# SERVICE BULLETIN #127

04/25/14

## 9560 Spoke Wheel

### Obsolete Part

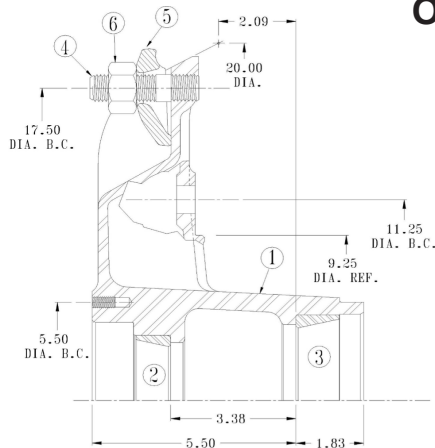
Upon depletion of inventory, the 9560 spoke will become obsolete with no direct replacement. We do however recommend a replacement: the 10-stud 2520 hub. This requires changing brake drums, changing to a disc hub, and changing to disc wheels instead of demountable rims. If you have any questions, please contact the Webb Engineering department via email to [engineering@webbwheel.com](mailto:engineering@webbwheel.com) or call 256-736-6356.
